CITY OF GOODLETTSVILLE PLANNING COMMISSION

MEETING AGENDA

Monday August 30, 2021 5:00 PM

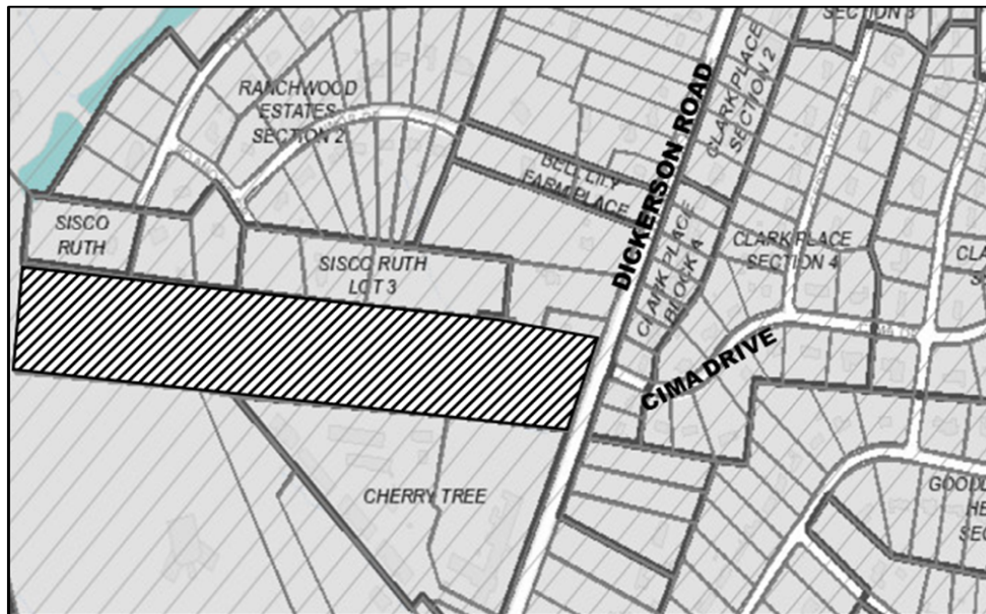
The project design includes a public exterior loop street with multiple small private drives for the residential unit connections. The City's Fire Marshal's review comment included a loop street design for emergency services traffic. The revised design includes the loop street with designated parking. The revised design has been reviewed and agreed upon by the City's Fire Marshal. The revised design includes a wider entrance roadway section to accommodate a three (3) lane entrance section for the possible use of multiple emergency vehicles.

The proposal includes revised building design requirements referencing City's Design Guidelines. The attached building architectural design graphic will be required to be revised to reflect the fifty (50%) percent brick or stone on all exterior elevations. The building designs include two (2) car garage dimension of twenty-one (21') feet x twenty and a half (20.5') feet. The Planning Commission at the August 2, 2021 meeting recommended a Zoning Ordinance amendment to the City Commission to include minimum twelve (12') x twenty-two (22') feet one car garage dimensions and twenty-two (22') feet x twenty-two (22') feet two (2) car garage dimensions. The City Commission at the August 26th meeting approved the garage dimension amendment on first reading.

An engineering traffic study will be required with the final master plan phase of the project. The revised plans include additional visitor parking areas in the one-way loop section on the south side of the project.

STAFF RECOMMENDATION: Approval with the following stipulations being included on the preliminary master plan submitted for City Commission review

1. Revised building design information including increase the garage dimensions and exterior elevations reflecting City's Design Guideline requirements and Planning Commission's determination on revised design including all two (2) story units versus a mixture of one and two (2) story units per original guidelines
2. Revised master plan defining the permitted commercial uses listed above for the commercial area at the front of the site
3. Restrictive covenants submitted with final master plan to include statement of for-sale units.

Proposed Comprehensive Plan Amendment Area:

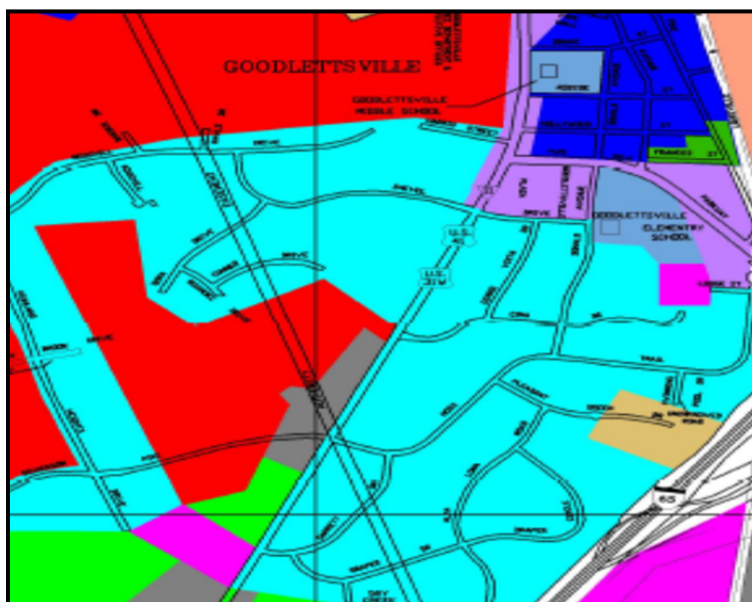
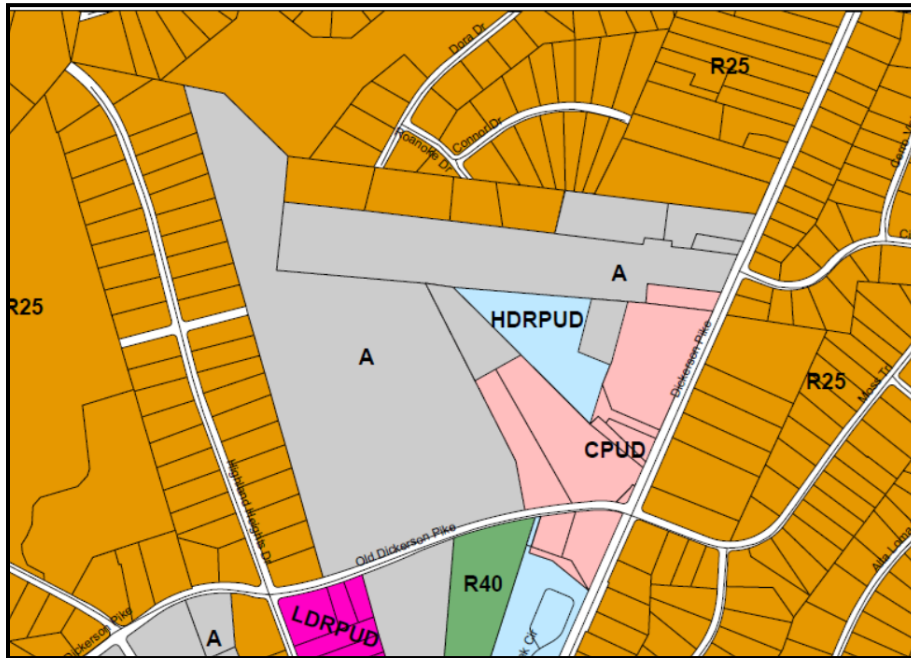
Approval due to the location of the amendment area on Dickerson Road-Hwy 41/SR 11 which is a designated minor arterial route on the City's Major Thoroughfare Plan (2003) and the area would provide a transition between zoned and existing commercial and apartment areas to the south and larger lot single family lots to the north.
